**REMARKS**

This Amendment is in response to the Final Office Action dated May 12, 2004. It is noted that the present Amendment is being filed as a Submission with Request for Continued Examination (RCE) being filed herewith.

Application No.: 09/943,512  
Art Unit: 2827

**AMENDMENTS TO THE DRAWINGS**

FIG.3  
(PRIOR ART)

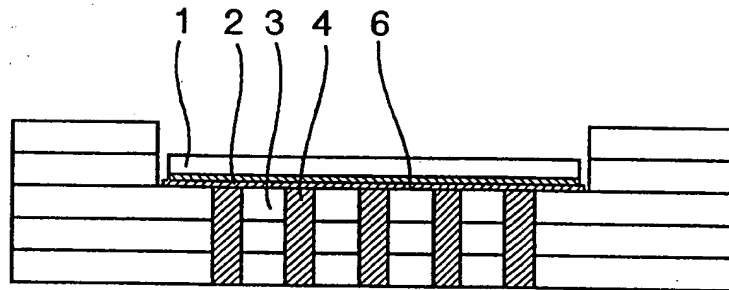
The attached sheet of drawings includes changes to Figs. 3, 4, 10 and 11. These sheets replace the original sheets showing Figs. 3, 4, 10 and 11. Each of Figs. 3, 4, 10 and 11 has been labeled as prior art, in response to the requirement to do so in the May 12, 2004 Final Office Action.

**FIG.10**  
(PRIOR ART)

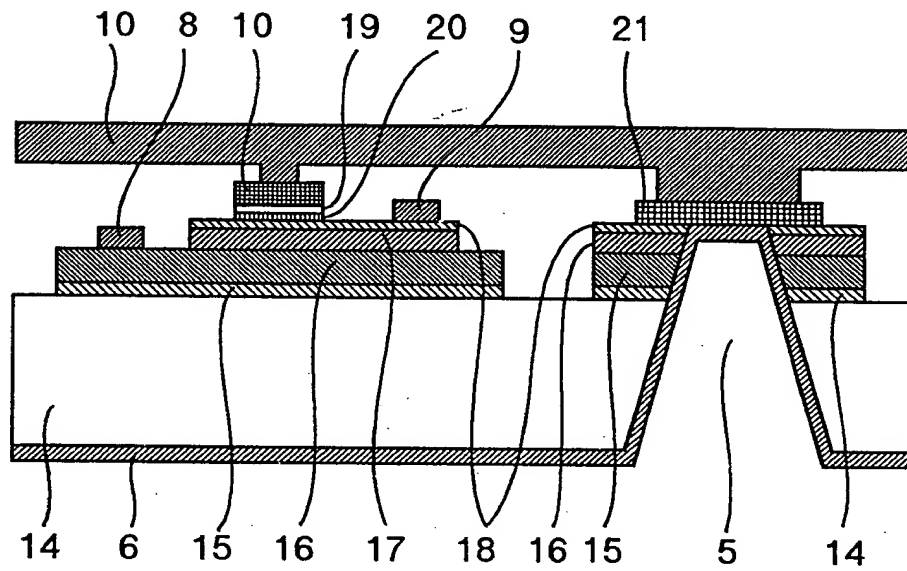
As a result, it is quite clear that there is no corollary for the claimed multilayer wiring board in Shirakawa. Quite to the contrary, Shirakawa merely discloses a substrate with a plated heat sink on the rear surface thereof, similar to that of the prior art shown in Fig. 10 of the present application. Accordingly, Shirakawa merely discloses a portion of the present claims, and completely lacks the claimed relationship between the substrate and the multilayer wiring board on which it is mounted. Therefore, reconsideration and allowance of claims 14-23, each of which specifically defines the relationship between the semiconductor substrate and the multilayer wiring board, is respectfully requested.
